TO: ALL VOLVO RETAILERS – US
RE: RECALL CAMPAIGN 139: INSPECTING THE FUEL TANK AND INSTALLING RUBBER DAMPERS

VOLVO				TITLE:		GROUP:	NO:	
				Inspecting the Fuel Tank and Installing Rubber Dampers		23	139	
Service Manager Bulletin				1994-1997 850		ISSUING DEPARTMENT:		
						Warranty		
				REFERENCE BULLETINS:		CARMARKET:		
				PB 23-139 TNN 23-24		United States		
Service Personnel: read and initial.	SERVICE MANAGER	SERVICE WRITER	WARRANTY ADMINISTRATOR	DATE:		YEAR	MONTH	DAY
				2004 09 23				
				Page 1 of 5

NO: 23 - 24
DATE: 9-23-2004
MODEL: 854 / 855
M. YEAR: 1994 - 1997
CHASSIS: (NOTE: RETAILERS MUST CONFIRM VEHICLE ELIGIBILITY)
SUBJECT: Recall Campaign 139
Inspecting the Fuel Tank and Installing Rubber Dampers.
REFERENCE: SMB 23 -139 / PB 23 - 139

Installing the rubber dampers

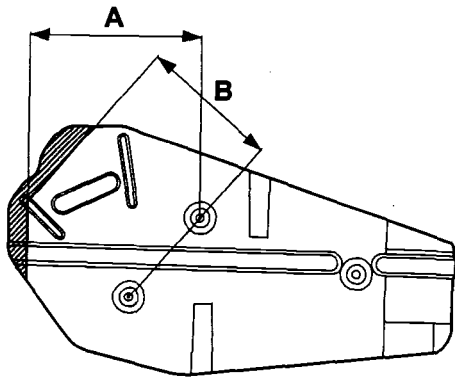
Install the rubber dampers to the lugs on the tank with the hexagon part of the damper facing the tank.

Tighten the rubber damper so that the hexagon just contacts with the lug surface, then angle tighten an additional 45° (1/8 of a turn).

Adjusting the protective plate

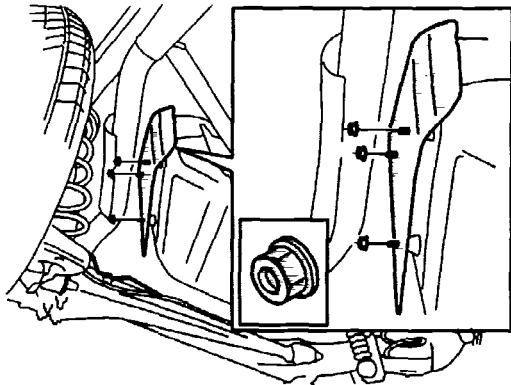
Cut off the shaded area as marked in the illustration.

A = 173 mm

B = 135 mm

Installing the rubber damper to the rear protective plate

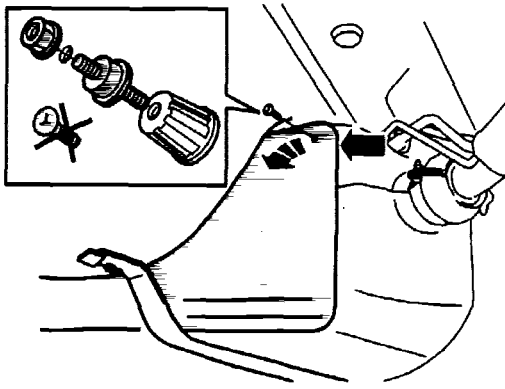
NOTE! Only applies to cars with a rear protective plate for the tank.

Install the rubber damper in the same way as in the previous steps.

Modifying pipe from rollover valve

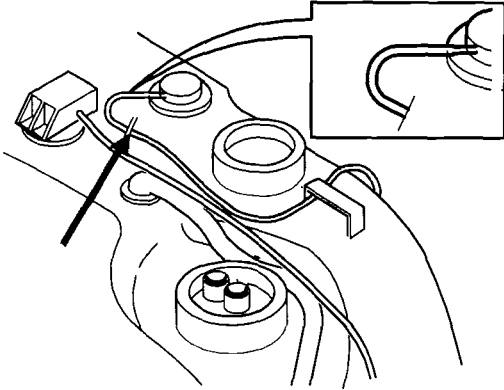
Cut the pipe on the new tank approx 25mm past the bend. See the illustration.

Adjusting the protective plate

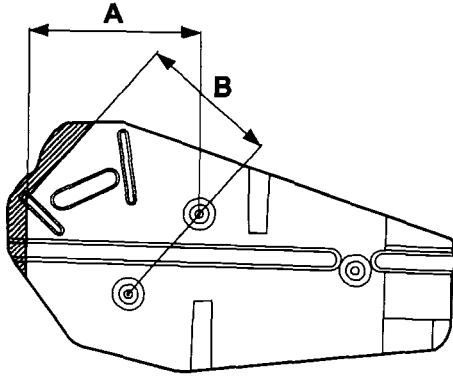
Cut off the shaded area marked in the illustration.

A = 173 mm

B = 135 mm
